CLASS 3 SITE PLAN REVIEW /CLASS 2 ADJUSTMENT CASE NO.: SPR-ADJ22-31

REQUEST: A consolidated application containing a Class 3 Site Plan Review to construct a new 5,418-square-foot overhead fuel canopy with 14 fueling positions, a 179-square-foot cashiers kiosk, and associated site improvements such as landscaping and vehicle parking. The application includes a Class 2 Adjustment request to reduce the minimum development site landscaping standard from 15 to 3.2 percent.

IN THE MATTER OF APPROVAL OF) FINDINGS & ORDER
CLASS 3 SITE PLAN REVIEW AND)
CLASS 2 ADJUSTMENT)
CASE NO. SPR-ADJ22-31)
2980 RIVER ROAD N - 97303) JULY 18, 2022

PRELIMINARY UTILITY PLAN
FRED MEYER
FUELING FACILITY

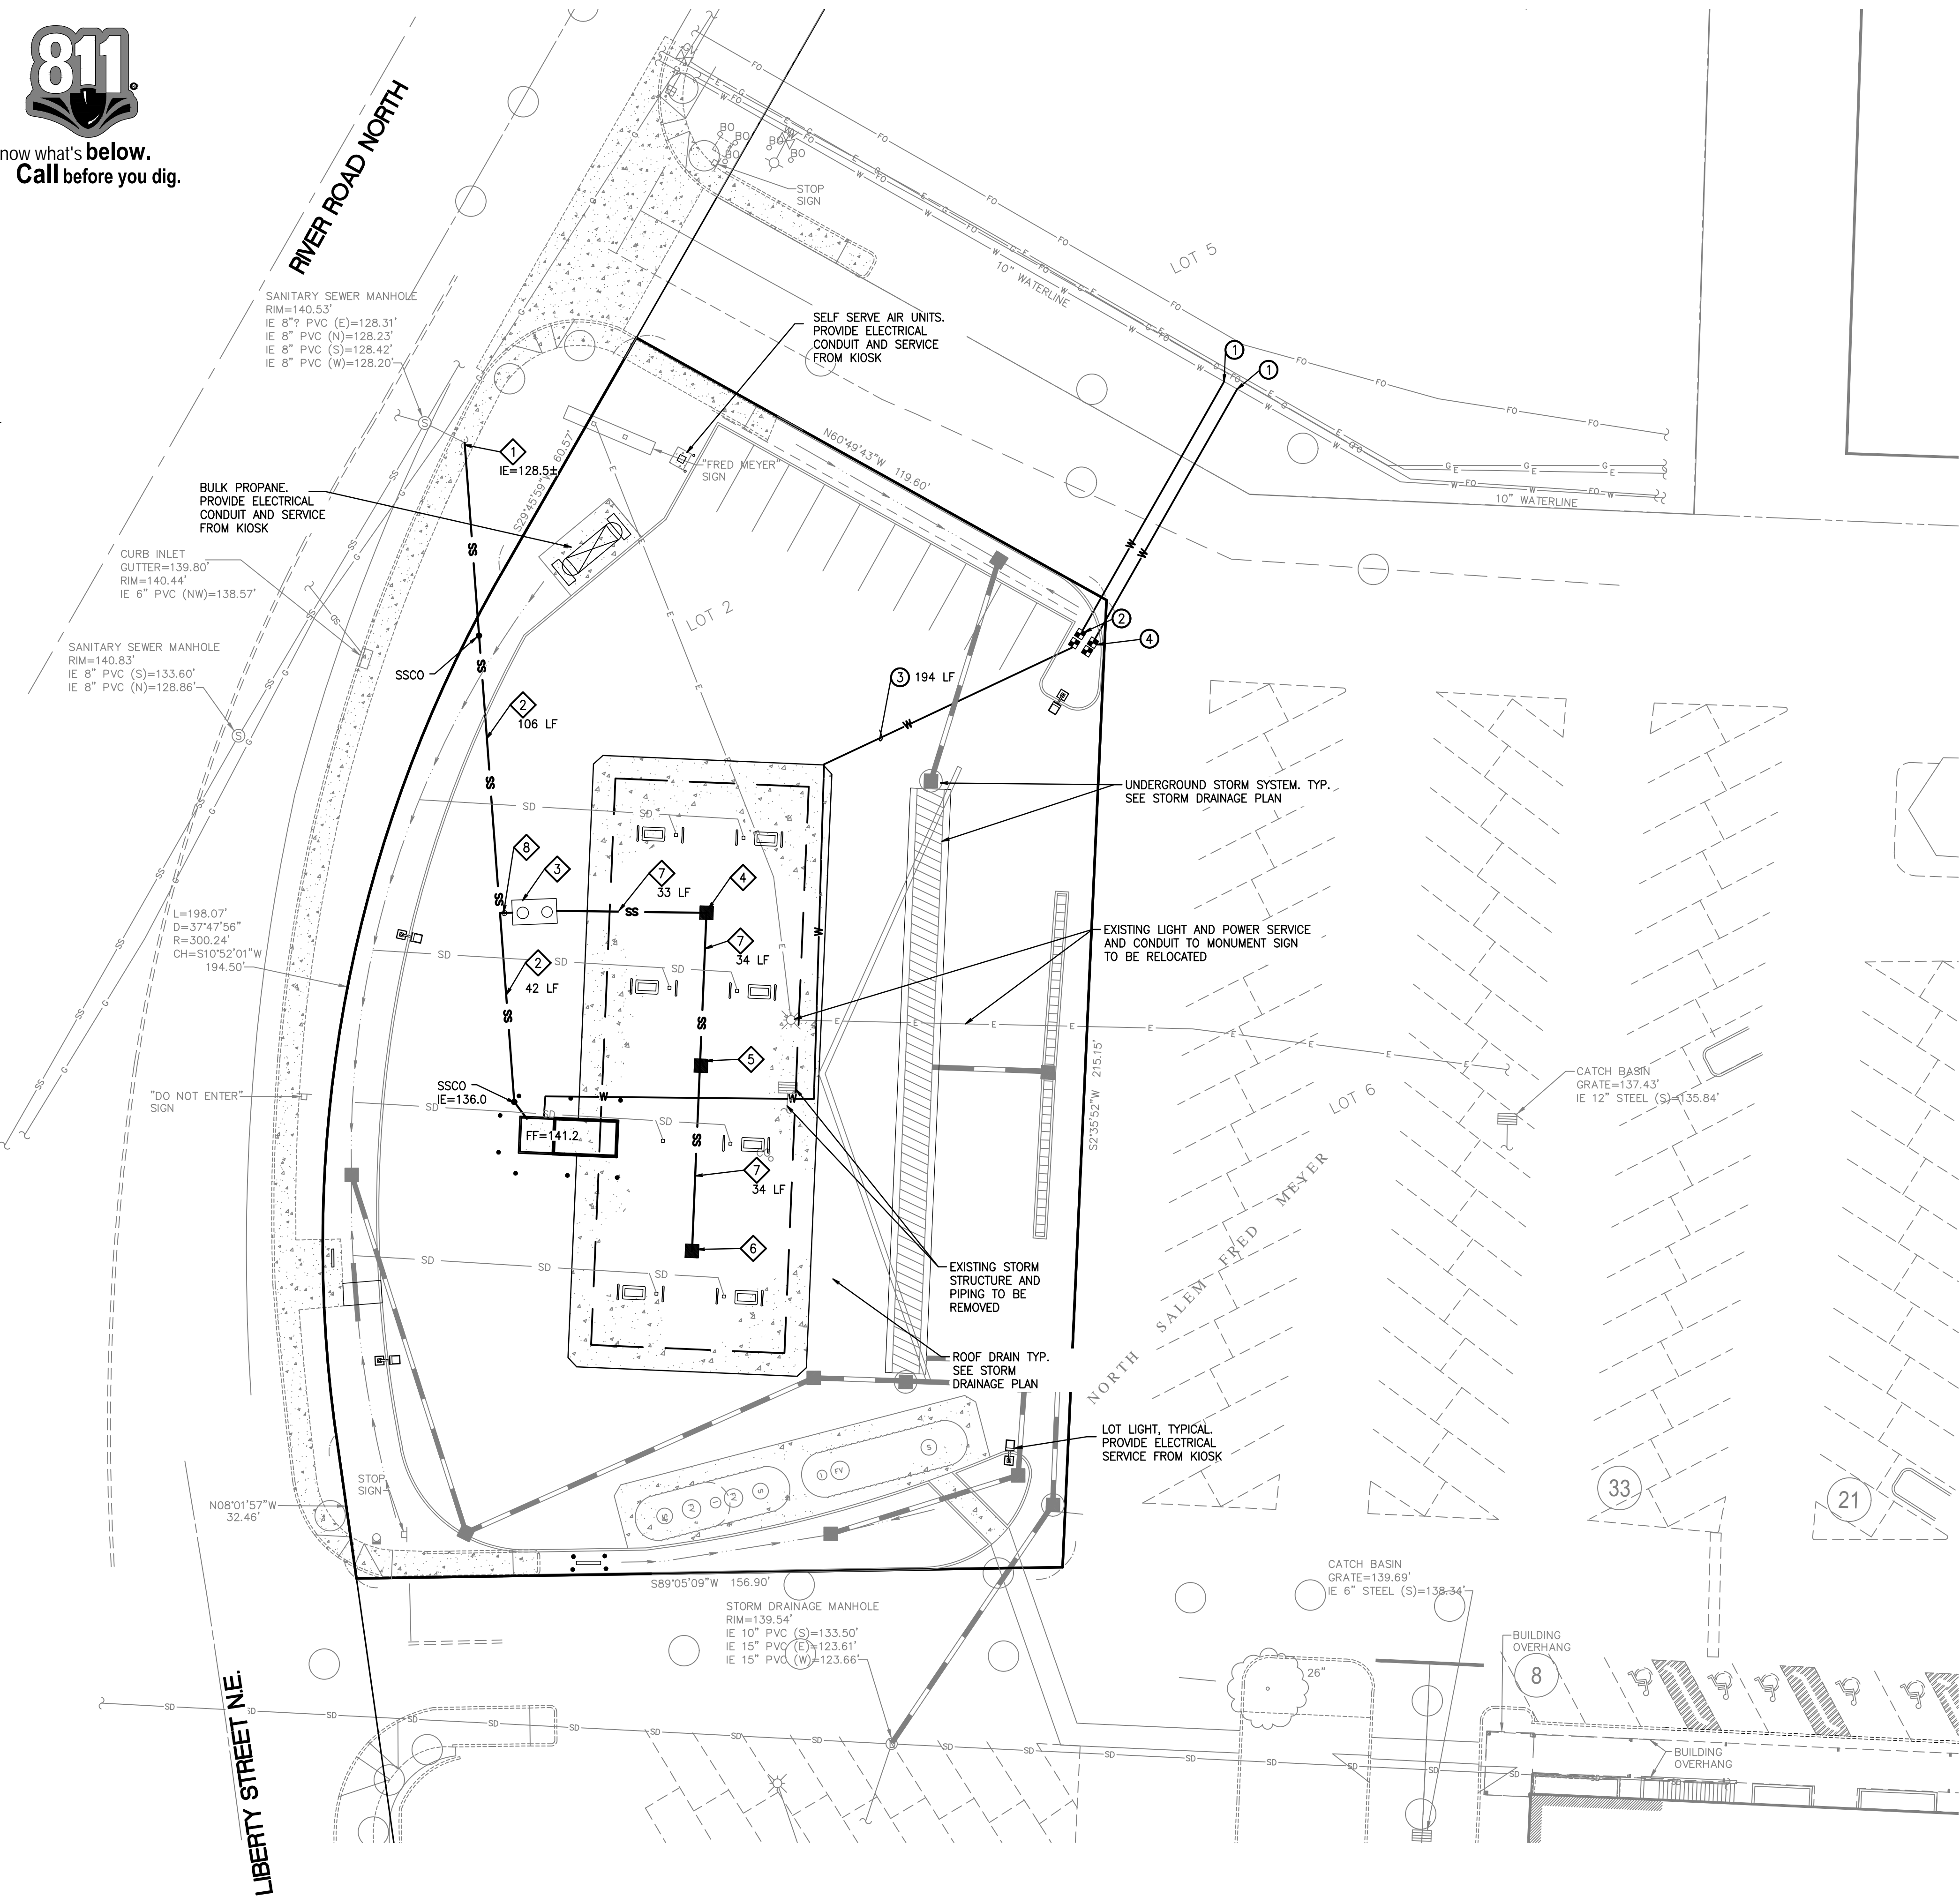
Finding—The Public Works Department has reviewed the applicant's preliminary plan for this site. The water, sewer, and storm infrastructure are available within surrounding streets/areas and are adequate to serve the proposed development. The applicants

preliminary site plan shows new water services crossing adjacent private property. The applicant is required to obtain easements for new City services on adjacent private property or demonstrate that an easement exists.

Condition: Provide public utility easements for City infrastructure on private property pursuant to PWDS.

PRELIMINARY GRADING
AND STORM DRAINAGE
FRED MEYER
FUELING FACILITY

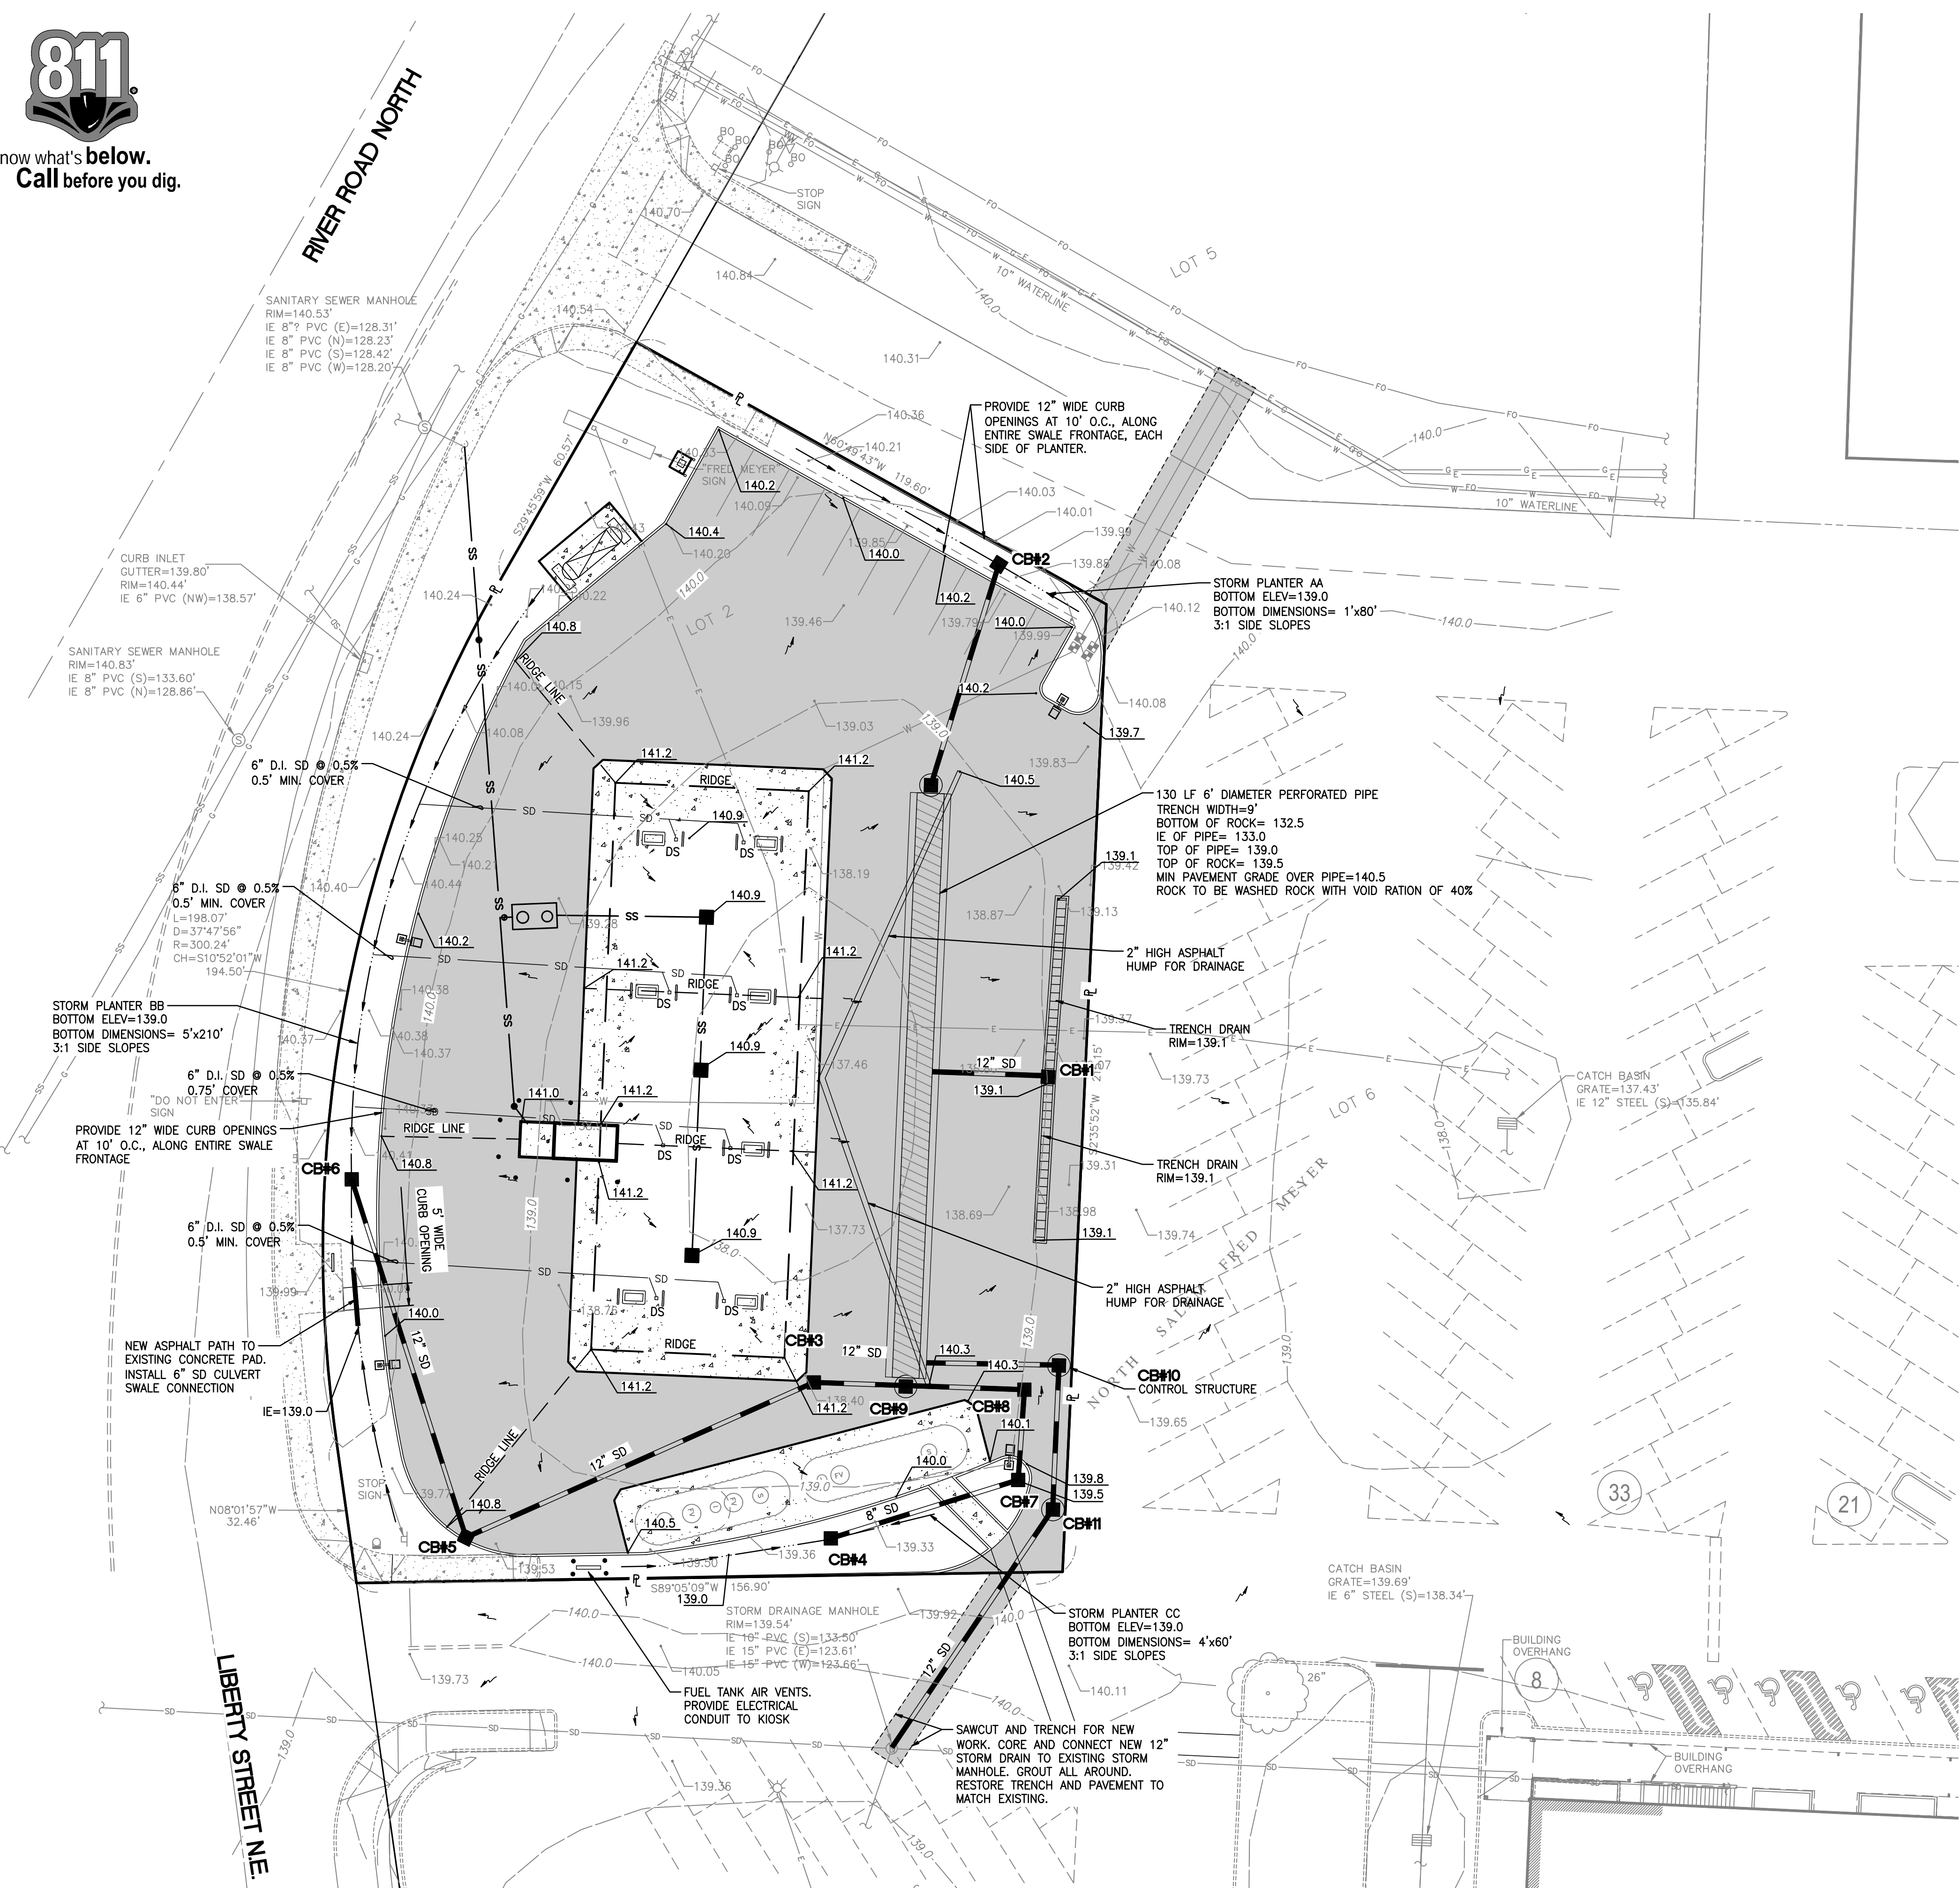
The proposed plan demonstrates compliance with PWDS Appendix 4E related to green stormwater infrastructure by setting aside at least ten percent of the total new impervious surface area for installation of green stormwater infrastructure. The applicant's engineer shall design and construct a storm drainage system at the time of development in compliance with SRC Chapter 71 and PWDS.

Condition 4: Design and construct a storm drainage system at the time of development in compliance with Salem Revised Code (SRC) Chapter 71 and Public Works Design Standards (PWDS).
